CHATHAM COUNTY PURCHASING & CONTRACTING DEPARTMENT

ADDENDUM NO. 2 TO 18-0075-4

FOR: CANEBRAKE ROAD IMPROVEMENTS

Canebrake Road – Plan Revisions – 7/31/18

CHATHAM COUNTY, GEORGIA
MAINLINE PLAN
CANEBRAKE ROAD IMPROVEMENT PROJECT
DRAWING No. 13-003

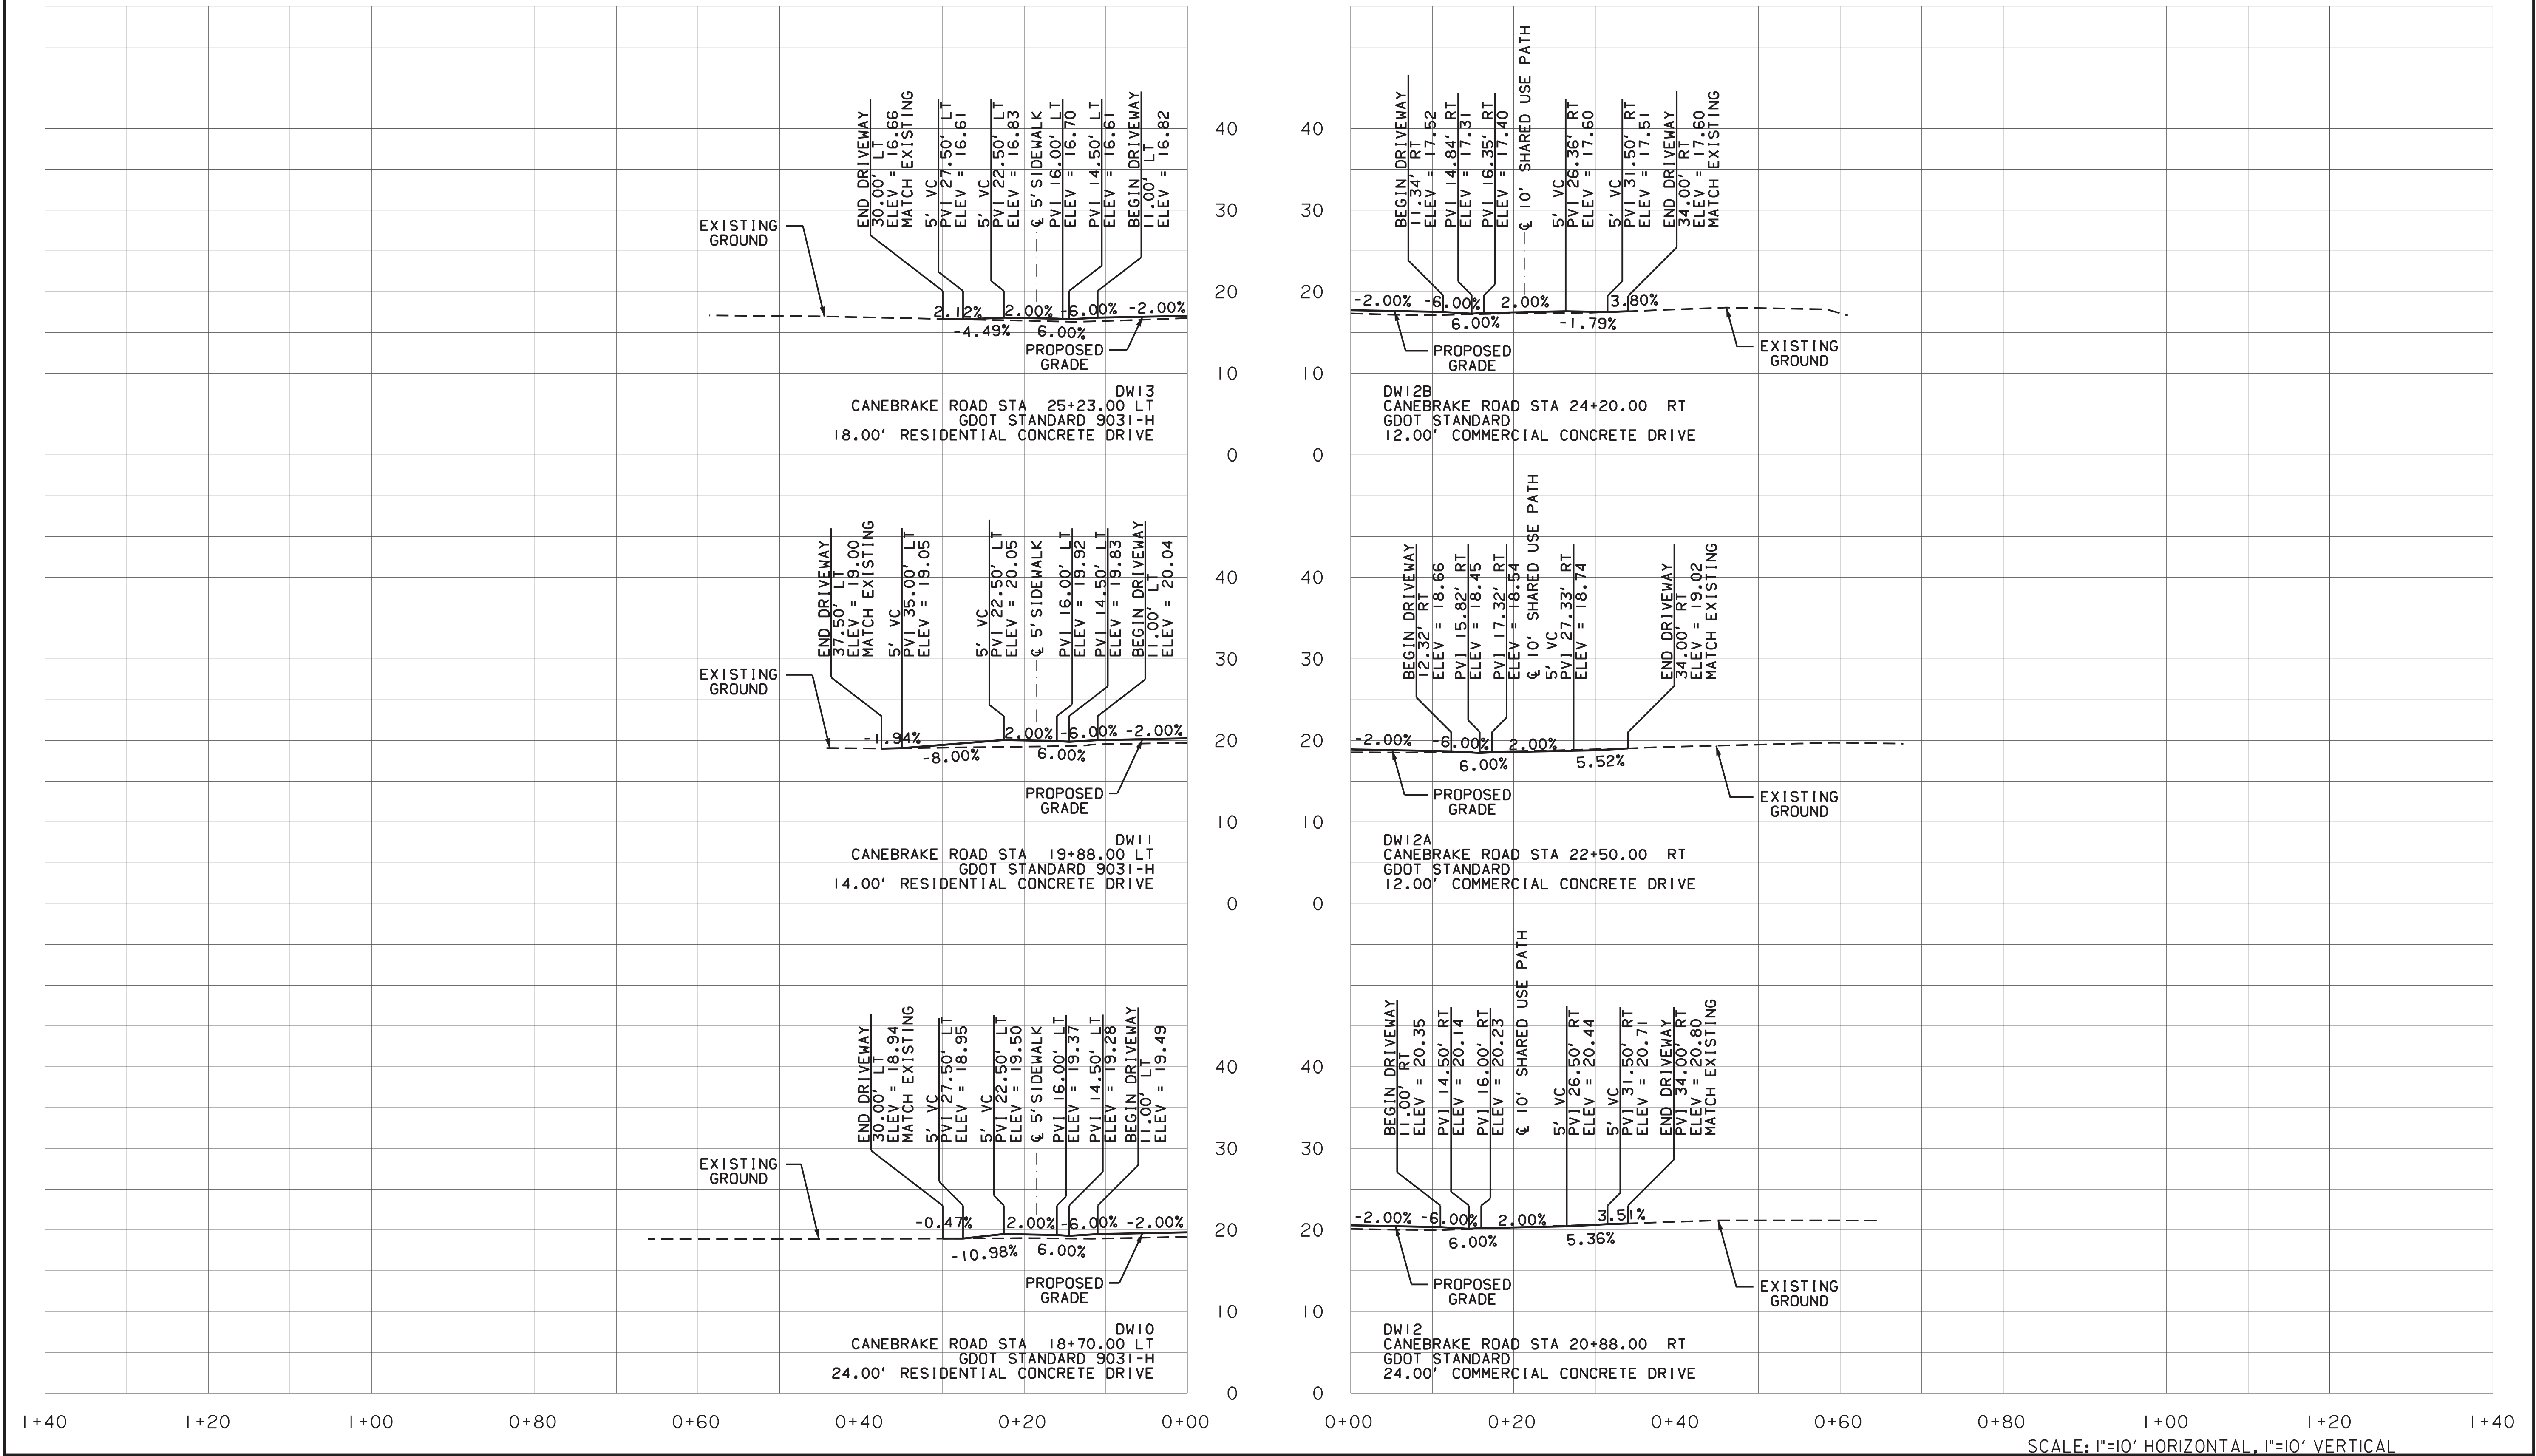
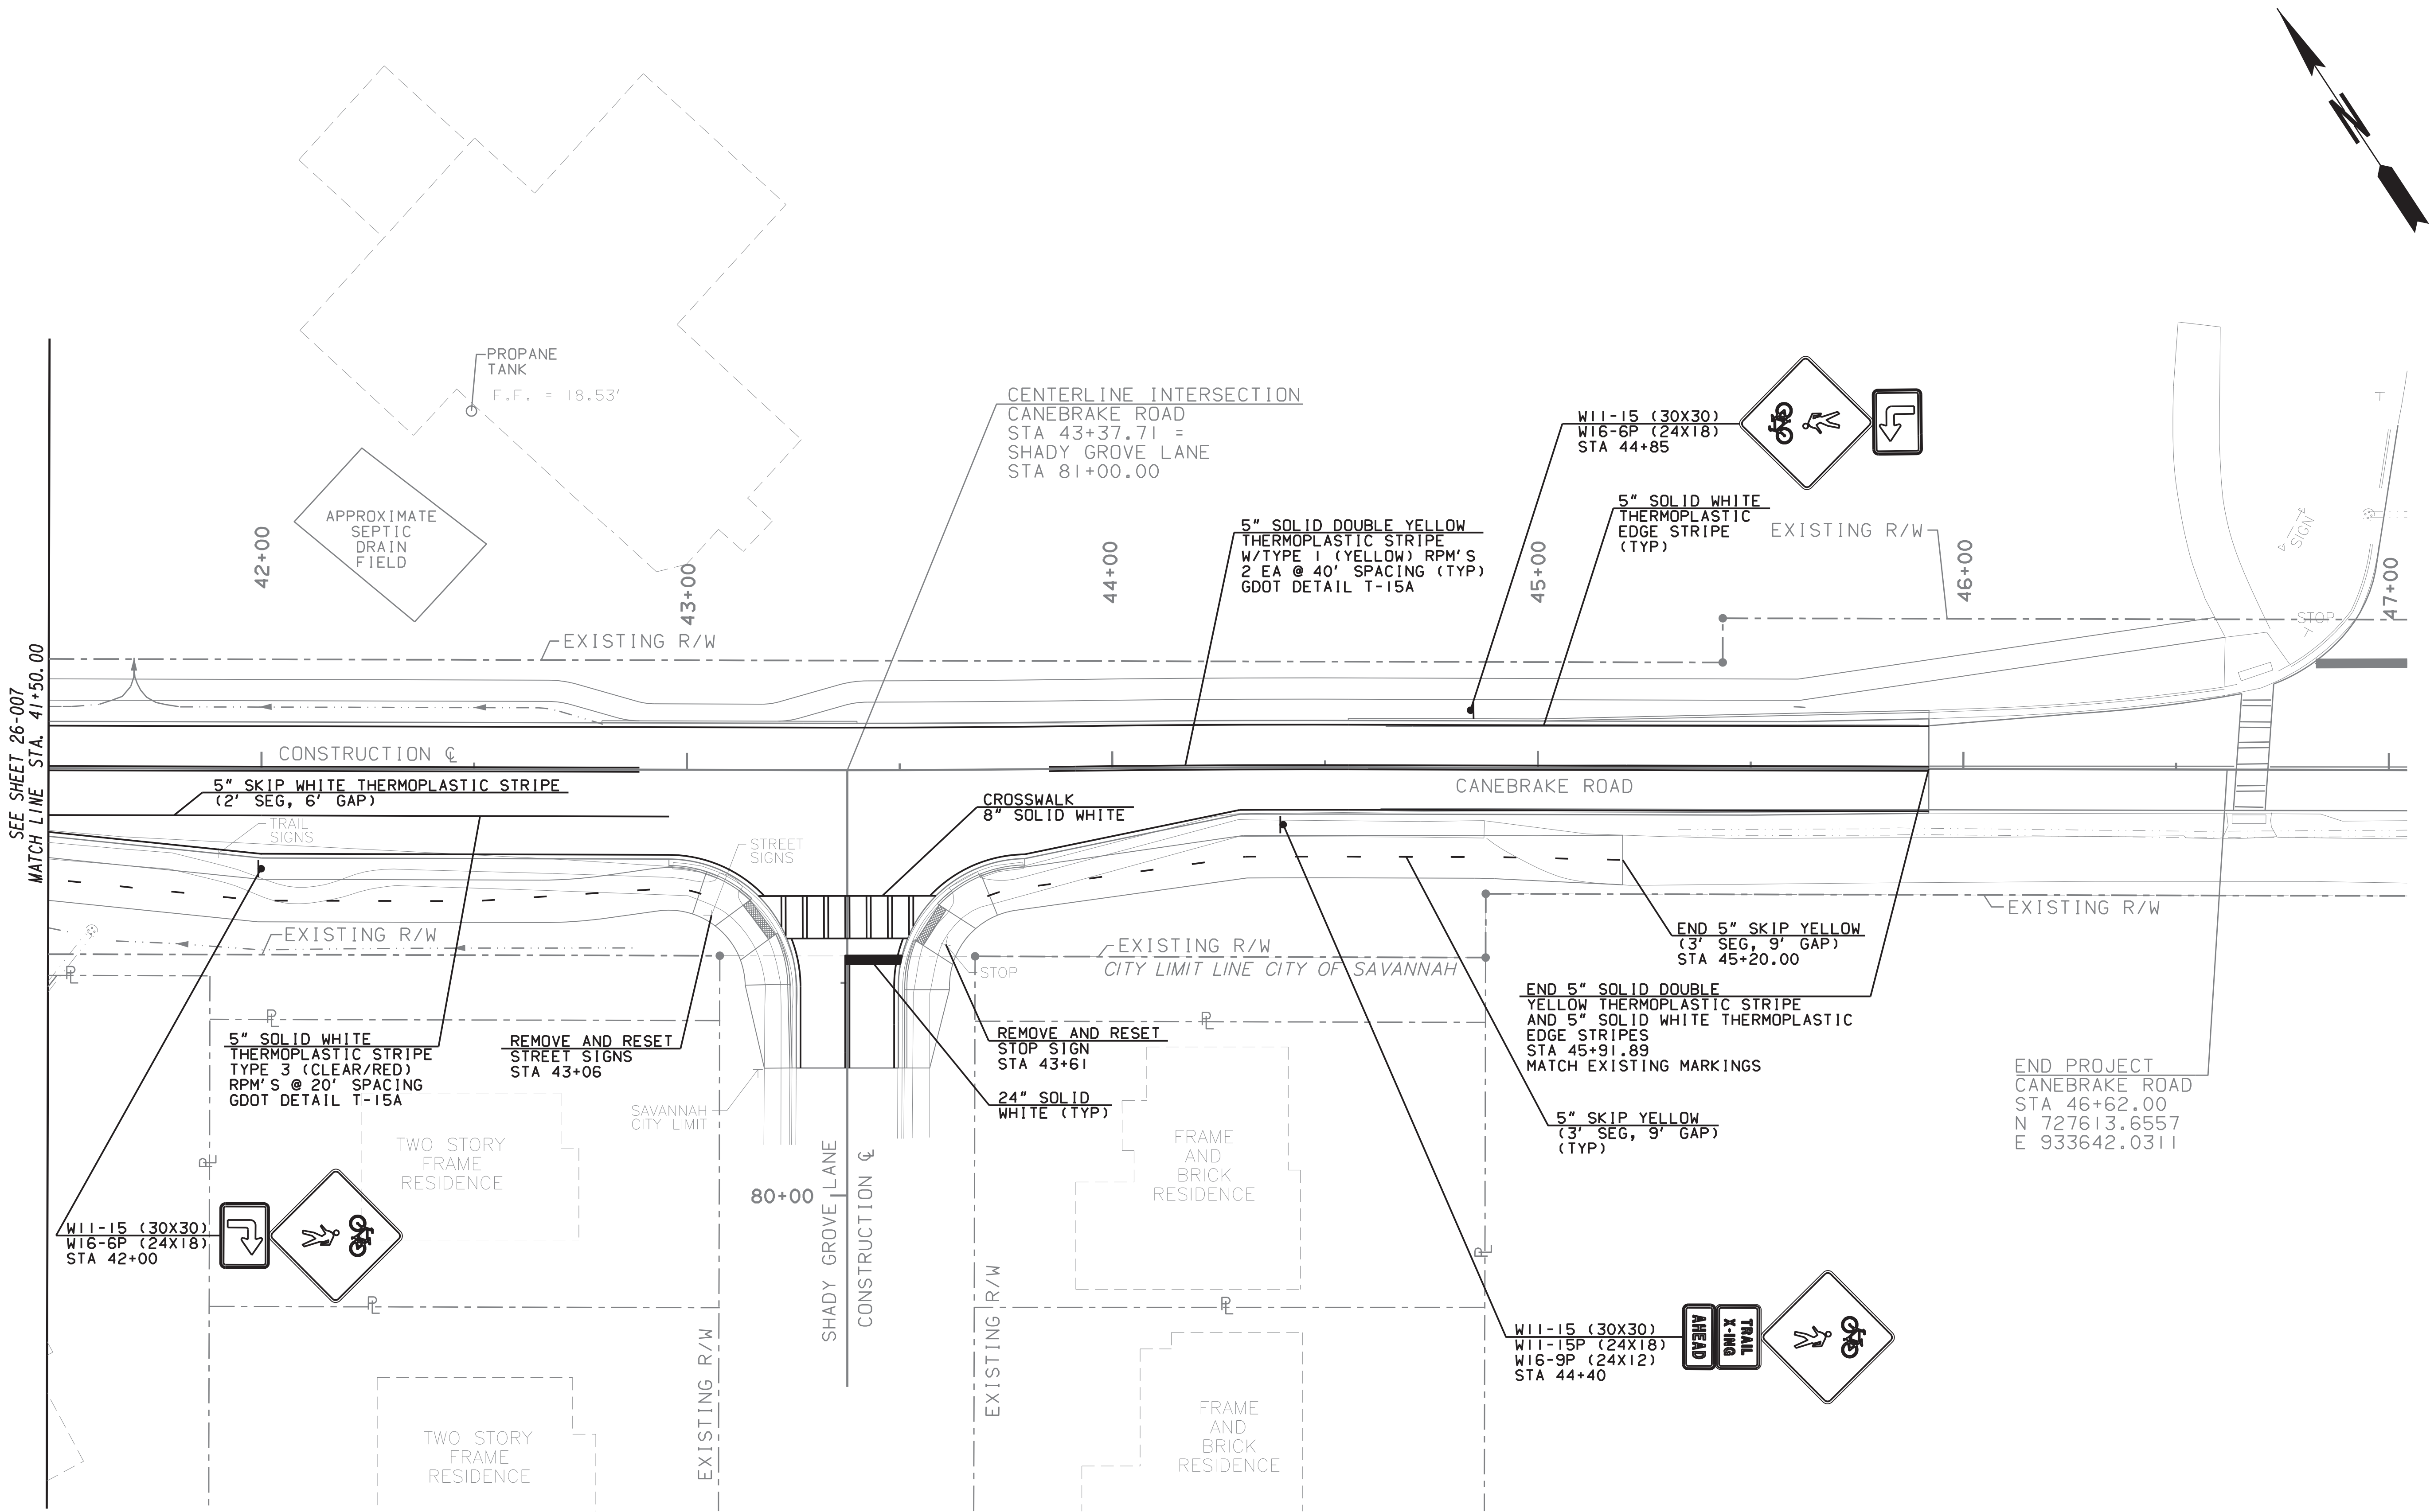
Sht 26-008: Added W11-15, W11-15P and W16-9P at 44+40 RT
